## **REMARKS/ARGUMENTS**

**Amendments to the Drawings:**

Appl. No. 10/034,412  
 Amdt. Dated Sept. 8, 2004  
 Reply to Office Action of April 8, 2004  
 Annotated Sheet 3 Showing Changes

*Fig. 4*

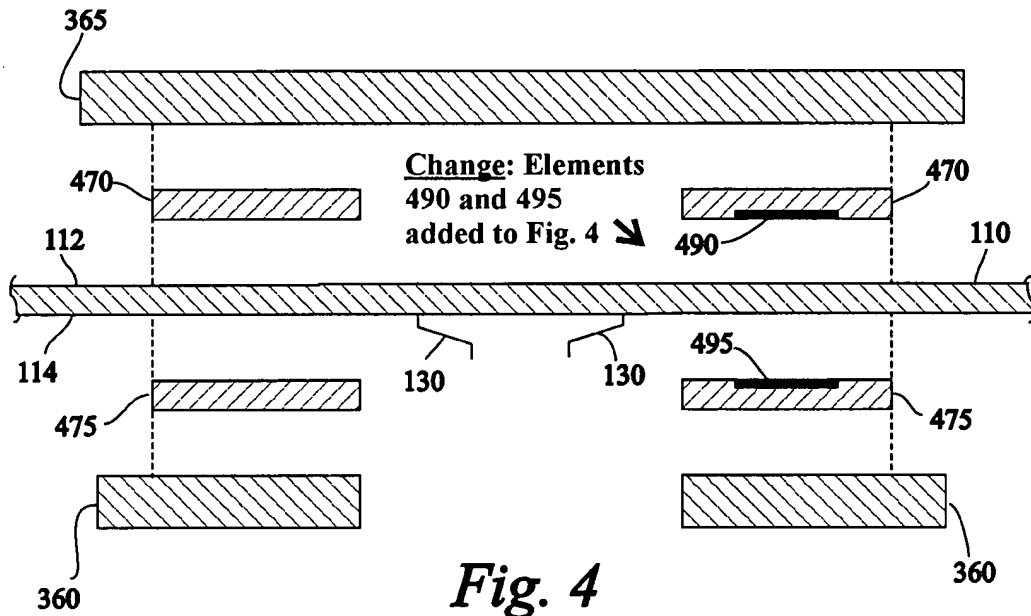
The drawings were objected to as allegedly not showing "means for transmitting energy to said probe card" (claim 1), "an optical sensor" (claims 3 and 8), and "a temperature sensor" (claim 15). Elements 470 and 475, among other elements of the drawings, illustrate examples of "means for transmitting energy to said probe card." Moreover, Figures 4 and 8 are amended to illustrate an example of an optical sensor and a temperature sensor. Therefore, at least one example of "means for transmitting energy to said probe card," "an optical sensor," and "a temperature sensor" are now illustrated in the drawings. Therefore, the objection to the drawings has been overcome.

Attached are two Replacement sheets replacing originally filed sheet 3 (Figures 4, 4A, and 4B) and sheet 8 (Figure 8) of the drawings. On sheet 3, in Figure 4, temperature sensing elements 490 and 495 are added. On sheet 8, in Figure 8, camera 500 is added.
